MACHINE SERVICE BULLETIN NO. 205

SUBJECT: Condenser for D.C. operation - LA, MA, and Gardner models.

DATE: October 9, 1934

- <u>LA</u> ----

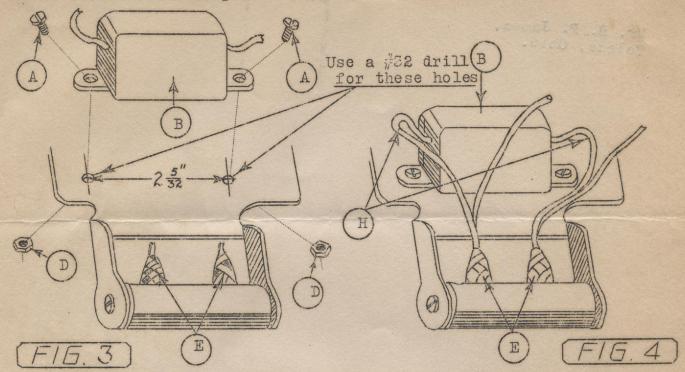
Where these models are requisitioned from Orange for D.C. operation, our standard procedure is to add a condenser in the circuit to provide proper speed control. The reason for using a condenser on D.C. is to dampen the arc at the governor contact points as the arc has a current carrying capacity which destroys the normal speed control of the governor.

Where delivery is made direct from district stock by applying machines containing standard motor equipment which does not always include a condenser, a condenser should be added to the circuit provided the motor specifications call for D.C. operation.

1- Remove eyelet from hole (C).

2- Drill a hole in bakelite strip (G) at (F) as shown in Figure 1.
3- Place condenser (B) over holes (C) and (F) and secure with two #6 screws (A) and #1256 nuts (D).
